St. Lucie Units 1 and 2
Docket Nos. 50-335 and 50-389

Florida Power & Light (FPL)/St. Lucie's First Overall Integrated Plan Status Report in Response to March 12, 2012 Commission Order Modifying Licenses with Regard to Requirements for Mitigation Strategies for Beyond-Design-Basis External Events (Order Number EA-12-049)

First Six Month Status Report for the Implementation of Order EA-12-049, Order Modifying Licenses with Regard to Requirements for Mitigation Strategies for Beyond-Design-Basis External Events

Figure 1 PSL FLEX Electrical Connections (Unit 1) (Rev 0A)

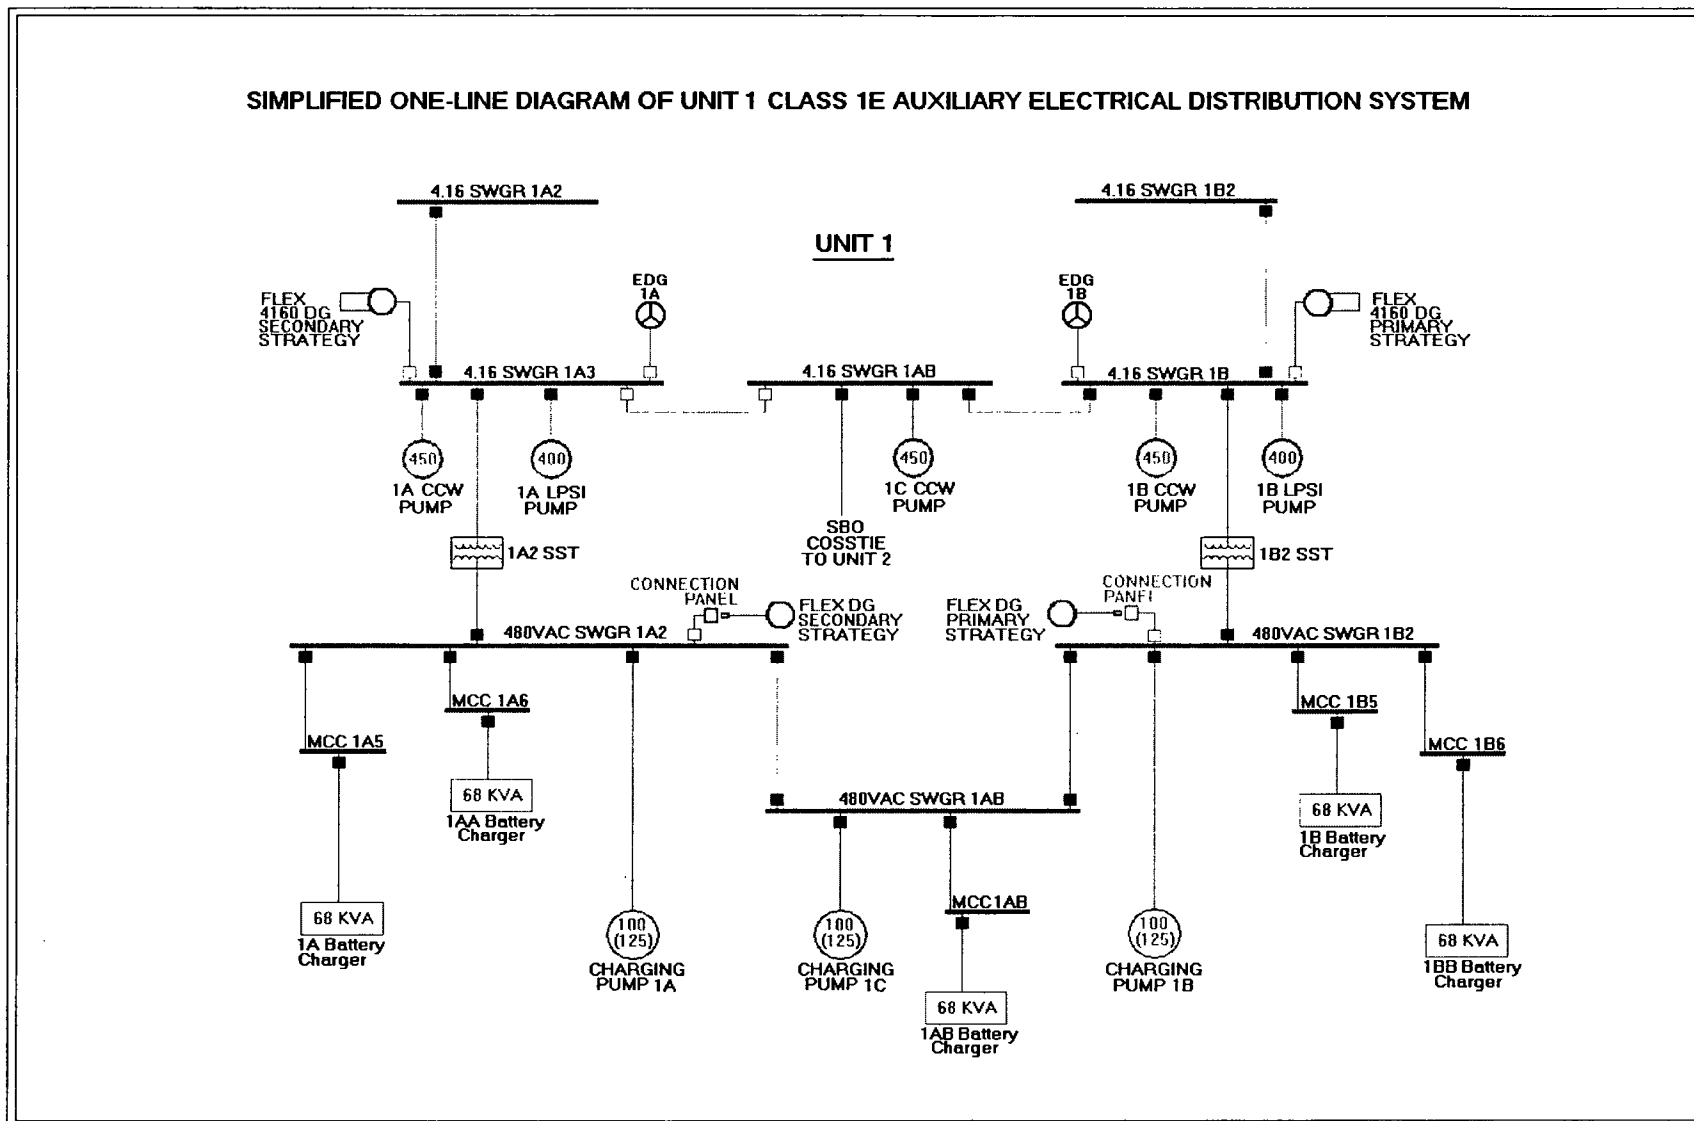
The St. Lucie FLEX strategy for making electrical system connections has evolved from that indicated in the Reference 1 response figures to be consistent with NEI 12-06 guidance (Reference 4). Refer to attached revised electrical connection figures. Note the 480 volt connections will now be made using procedurally controlled breakers rather than using transfer switches.

Figure 11 Connections for CST FLEX Pump Suction on CSTs (Rev 0A)

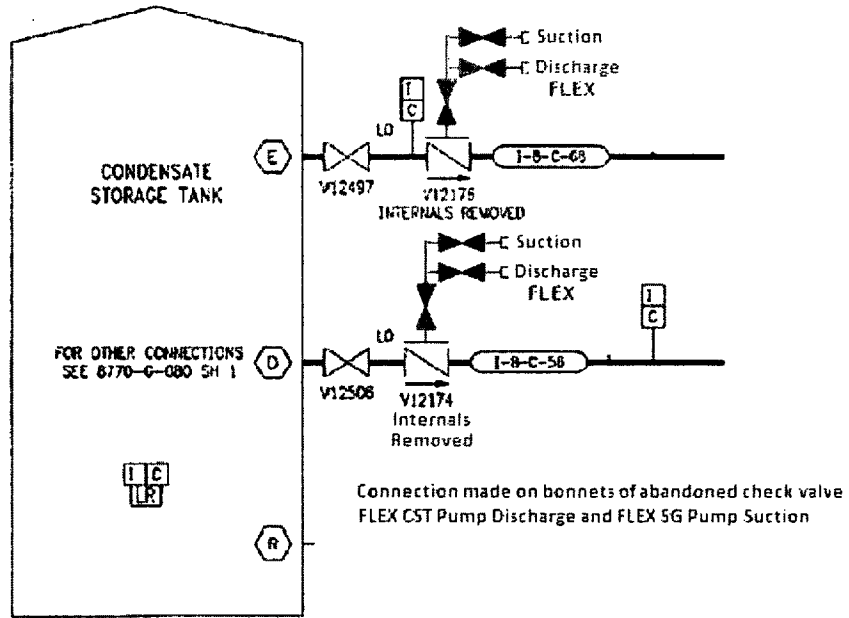
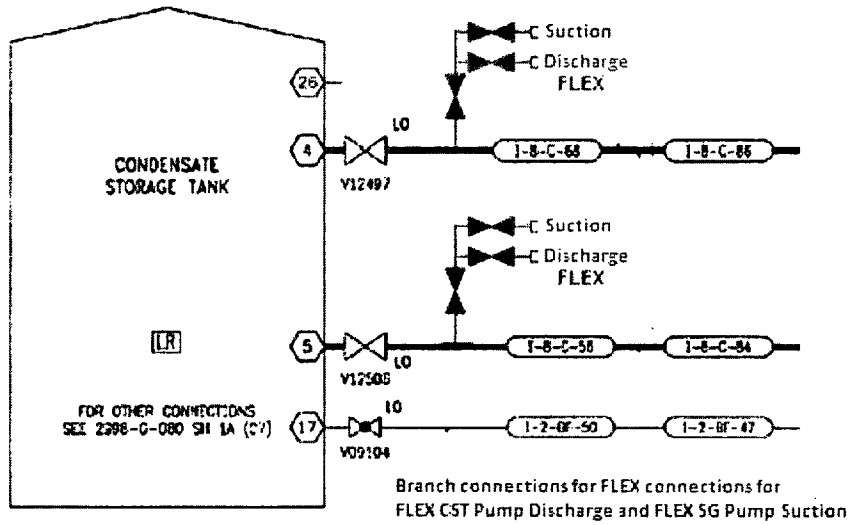
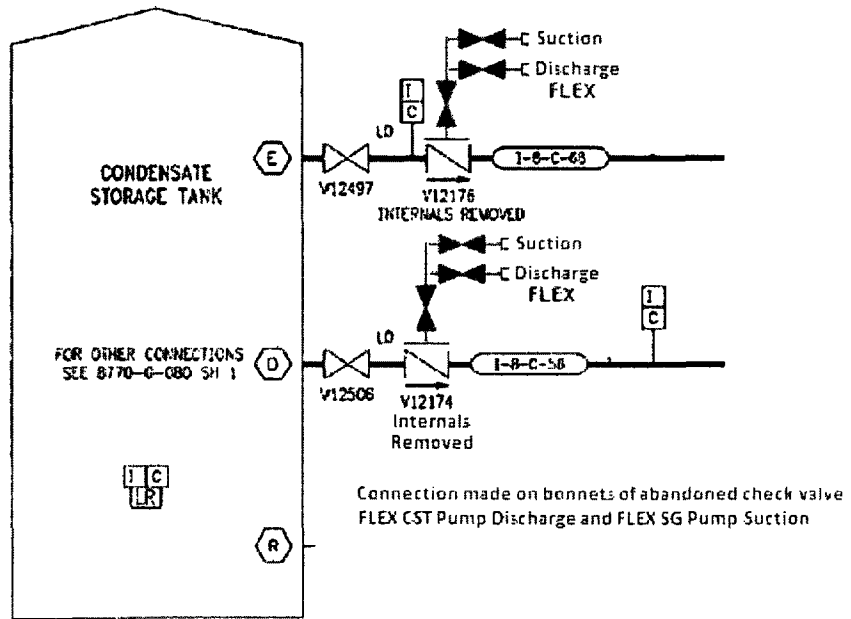
The St. Lucie FLEX strategy for making mechanical system connections has evolved from that indicated in Reference 1 response figures to be consistent with NEI 12-06 guidance (Reference 4). Secondary connections may require reconfiguration (e.g., removal of valve bonnet or disassembly of a flanged pipe joint) if validated that time and resources are reasonably available to support the reconfiguration. Location of the connection points provide reasonable assurance that at least one connection will be available for all applicable hazards. Refer to attached revised mechanical connection figures.

Figure 14 Connections for SG FLEX Pump Discharge to LPSI Pump Discharge Lines (Rev 0A)

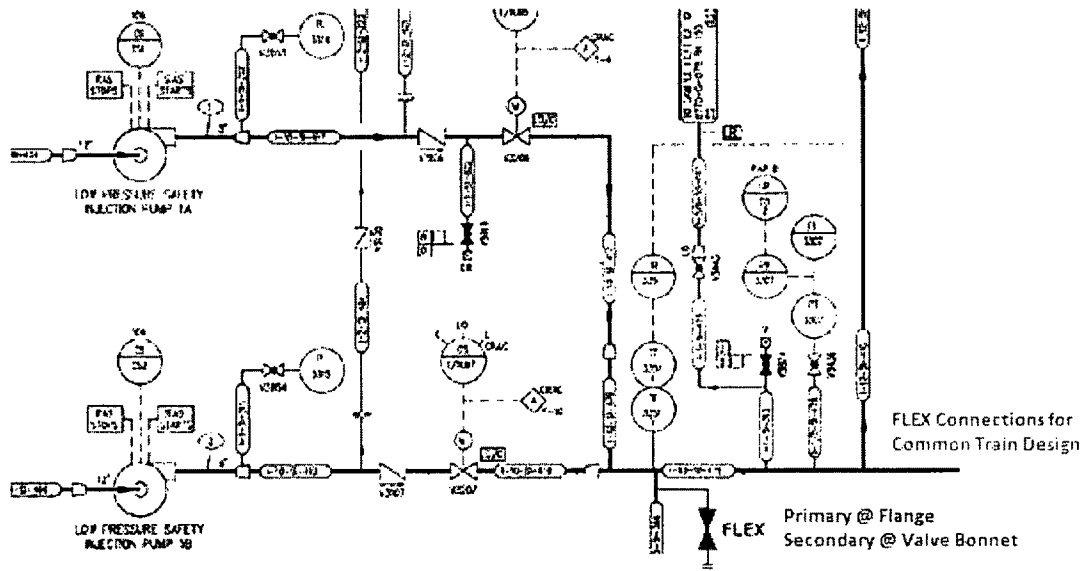
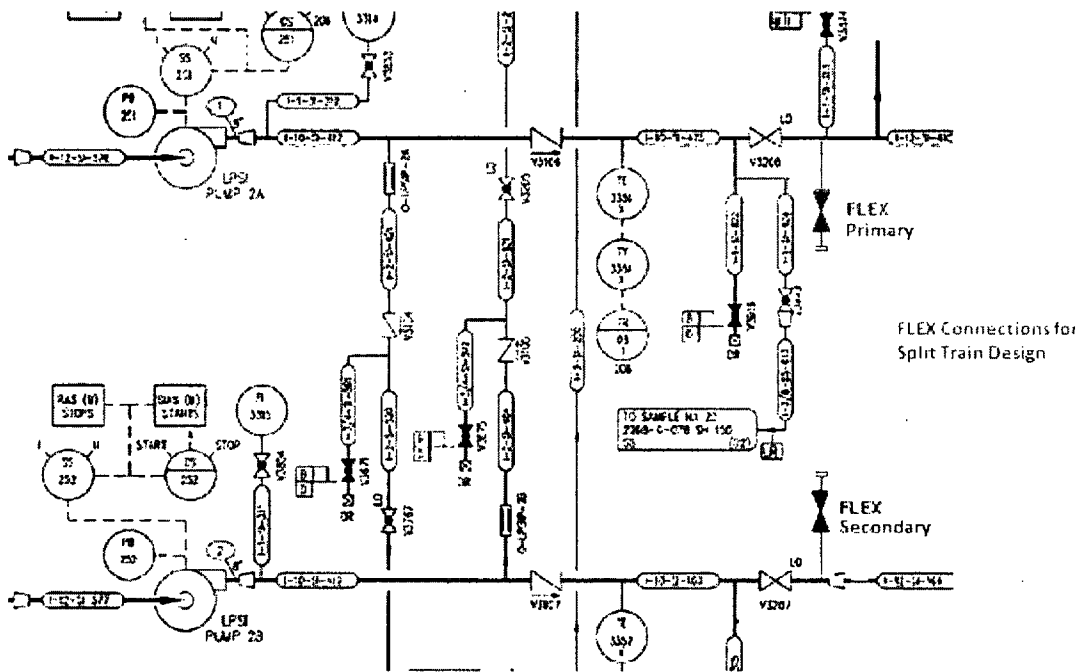
Install a 3" – 4" isolation valve and hose connection on the LPSI 1A/1B and LPSI 2A/2B discharge piping. For RCS cold leg injection with FLEX pump drawing suction from the RWT.

Figure 17 Connections for RRC LUHS Pumping System (Unit 1) (Rev 0A)

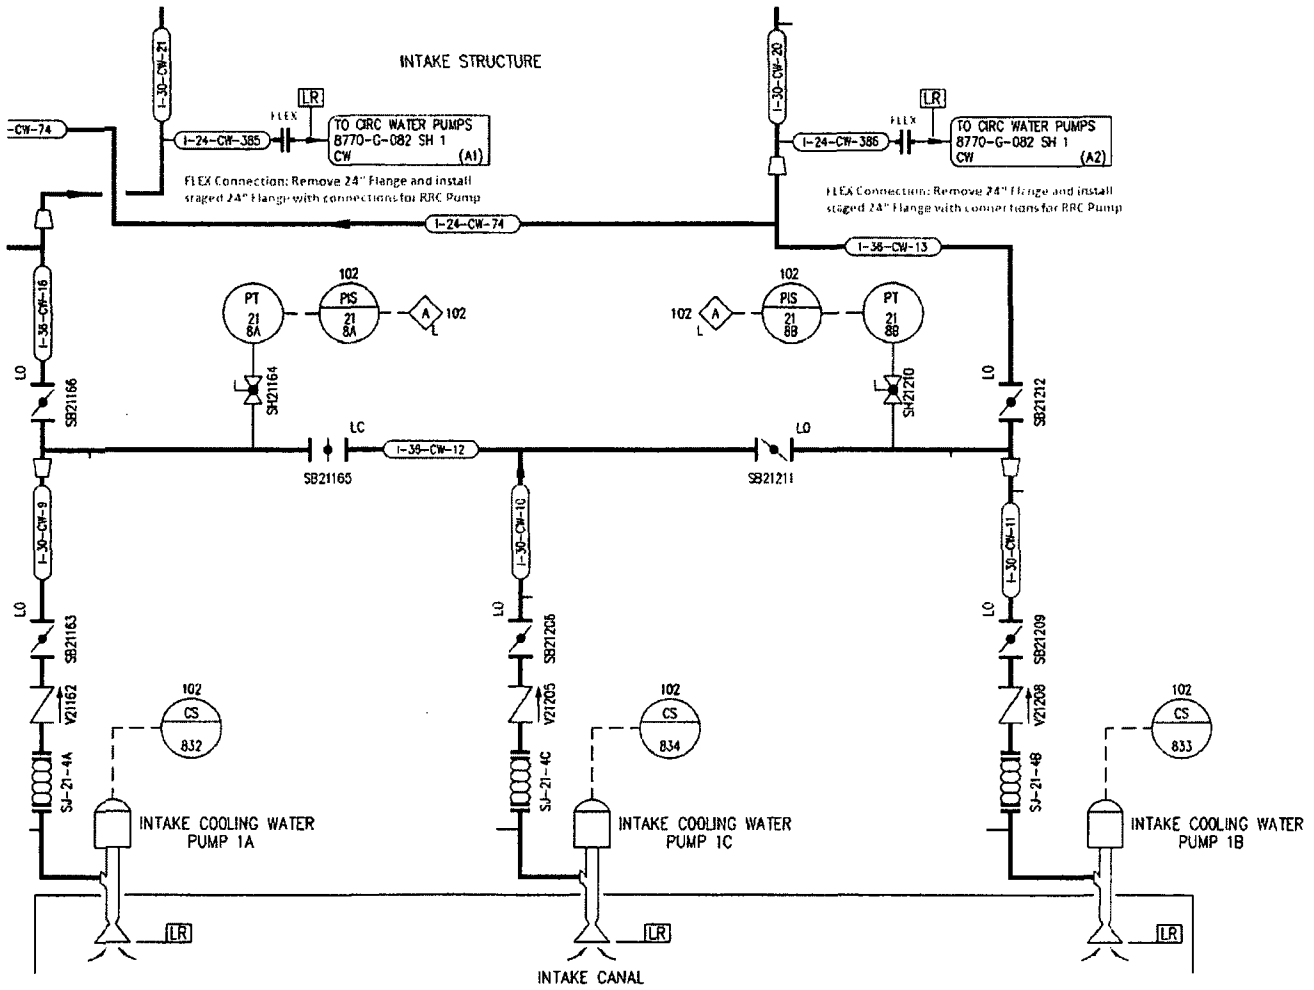
The Reference 1 FLEX response (page 68 of 102) indicated a pump would be provided from the Regional Response Center (RRC) to replace the function of the Intake Cooling Water Pumps due to the Loss of Ultimate Heat Sink (LUHS) event. The design point of the SAFER RRC pump is subject to final

procurement but is expected to be 5000 gpm at 150 psi. The LUHS Pump criteria mentioned in Reference 1 (page 72 of 102; 7162 gpm, 90 psi) will be altered to align with SAFER provided equipment and demonstrated to be sufficient for the purpose of reinstating Phase 3 Shutdown Cooling.
